PROPOSED VISITOR ACCOMMODATION AT 28 OLIVE STREET, NEWSTEAD

ANNEX A to DA0251/2021

Parking Space Surface Treatment.

DRAWN: T.D.GUNN		DATE: 15/06/2021	PROJECT No.	DRAWING No.	REV.
		ALTH: T.D.GUNN		DATE: 15/06/2021	TG 001	004	1
		STATUS: CONVERSION		SCALE: 1 : 200			
PROPOSED VISITOR ACCOMMODATION AT 28 OLIVE STREET, NEWSTEAD FOR T.D.GUNN Stormwater Runoff

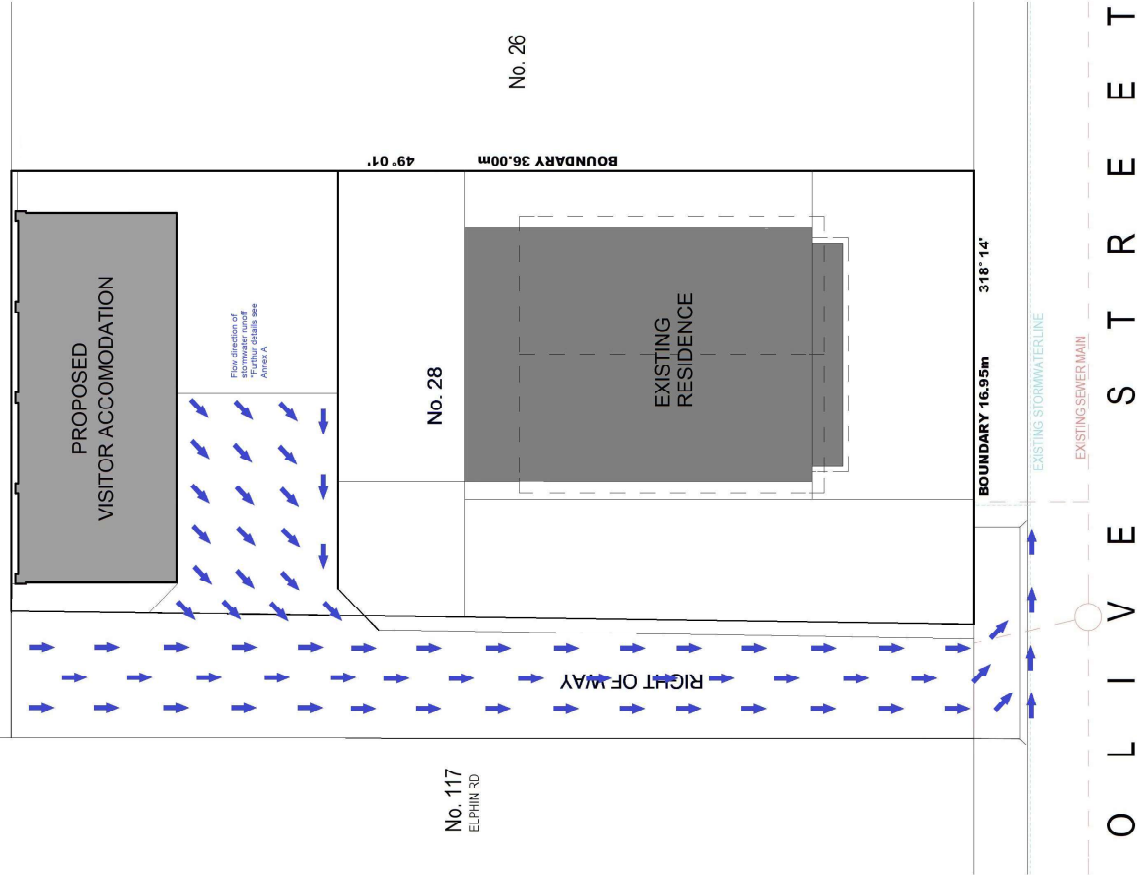
"E6.0 Parking and Sustainable Transport Code E6.6.1 A1 (b)" states "All parking, access ways, manoeuvring and circulation spaces must be formed and paved"

Parking space access.

"E6.0 Parking and Sustainable Transport Code Table E6.3" Calls for a combined access and manoeuvring width of only 6.4m to access a 5.4m x 2.6m, this proposal has over 7.5m

The finish to all these areas will be sealed asphalt as shown in submitted "Drawing 005 Rev1"

Earthworks required to achieve this will be the removal of 400mm of top soil in those areas where there is currently grass and replaced with 400mm of compacted road base prior to installation of asphalt surface. The existing areas marked as gravel in these location already consists of 400mm compacted road base.

A higher standard exists in *"AS/NZS 2890.1 Off Street Parking Table 1.1"* which provides 6 different classifications of off street parking. As the property is located in the zoning for General Residential and is primarily a domestic property the most accurate class identification is Class 1A described as *"Residential, domestic and employee parking"* the requirement under this table is *"three-point turn entry and exit into 90deg spaces only"* and subsequently under *"AS/NZS 2890.1 Off Street Parking Figure 2.2"* require an aisle width or only 5.8m. Therefore there is no requirement for a B85 single manoeuvre 5.4m radius in using this class.

However there is adequate manoeuvring clearance to achieve a Class 3 level which *"AS/NZS 2890.1 Off Street Parking Table 1.1" States as "Short-term and town centre parking, parking stations, hospitals, medical centres" requiring "Minimum for single manoeuvre entry and exit"* and therefore requires the use of a B85 5.8m swept path under *"AS/NZS 2890.1 B3 Swept Paths B3.1 (b)" which states "The B85 template comprises an inner pair of unbroken lines representing the B85 base dimension swept path, and an outer pair of broken lines which includes the manoeuvring clearance"* and *"AS/NZS 2890.1 B3 Swept Paths B3.2 (a)" states "a clearance of 300mm shall be added to both sides of the turning path"*. "Drawing 002 Rev2" details both this 5.8m swept path and the additional 300mm manoeuvring clearance. Further to this *"AS/NZS 2890.1 B4 Parking spaces and parking aisles B4.1" states "where there is an obstruction adjacent to a space, e.g. a wall, column, shrubs or landscaped area, an additional 300mm clearance is to be provided to the obstruction to achieve the desired level of service."* As this is the case adjacent to these spaces there is an additional 450mm clearance on both sides 1.5x the required amount.

Taking into account all the above documentation the manoeuvring clearance meets not only the minimal requirements but meets the most stringent of these as well.

There will be no gate between Right Of Way and parking spaces therefore no gate is shown on plans.
